**MONTGOMERY COUNTY DEPARTMENT OF PARK AND PLANNING**

MCPB  
Item No. 2  
2-16-06

**MEMORANDUM**

SUBJECT: Redland Road Sidewalk Phase I Transportation Facility Planning Study  
Project Prospectus Recommendations

Figure 2. Typical Sections

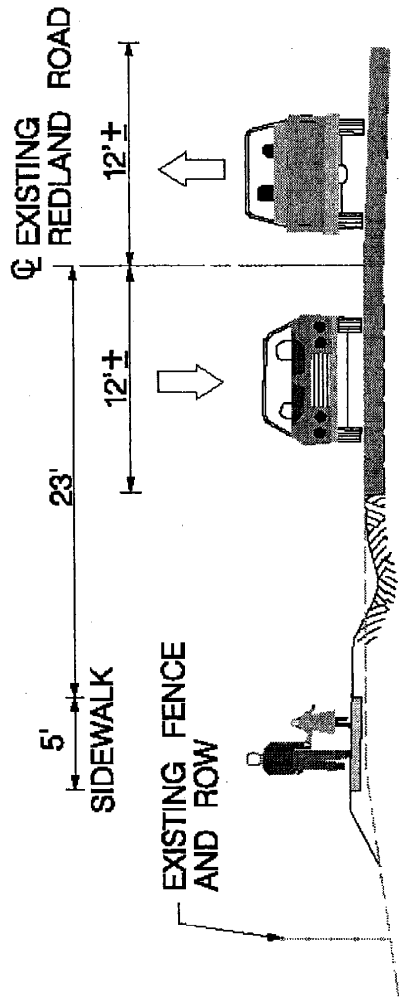
2. Within the Mill Creek Stream Valley Park, the sidewalk location should be shifted slightly toward the roadway edge to minimize parkland impacts. More detailed design is needed to refine the sidewalk location, but the M-NCPPC objectives for this section of the project are to:

- c. Separate the pedestrian facility from travel lanes by a safe and comfortable buffer, with a desired width of six feet and a minimum of three feet.

Typical sections for the Recommended Alternative are shown in Figure 2. The sidewalk is designed to be separated from the travel lanes by a drainage swale. Outside the Mill Creek Stream Valley Park, the typical section locates the sidewalk approximately 11 feet from the

current edge of pavement. This location provides an adequate buffer from the current edge of the travel lanes and is designed to facilitate implementation of the master planned bike lanes with a curb-and-gutter section including a landscape panel wide enough to support street trees. Within the Mill Creek Stream Valley Park the typical section appears wider, reflecting the fact that the sidewalk elevation will need to be independent of the adjacent roadway elevation depending upon surrounding terrain and ADA grade requirements. Within the park area, the design incorporates the use of retaining walls to minimize grading and associated environmental impacts.

The Recommended Alternative is derived from Alternative II, but locates the sidewalk two feet closer to the roadway to lessen slope and tree impact in the park area. This is the closest the sidewalk can be moved toward the road in an attempt to mitigate environmental impacts while providing an ADA compliant sidewalk and accommodating room for future bike lanes and landscape panel with street trees. To the extent that further refinements are made to the sidewalk location in parkland during Phase II, **staff recommends the objectives defined in comment #2, minimizing impacts to the natural environment while providing ADA compatibility and separating pedestrians from adjacent travel lanes.**
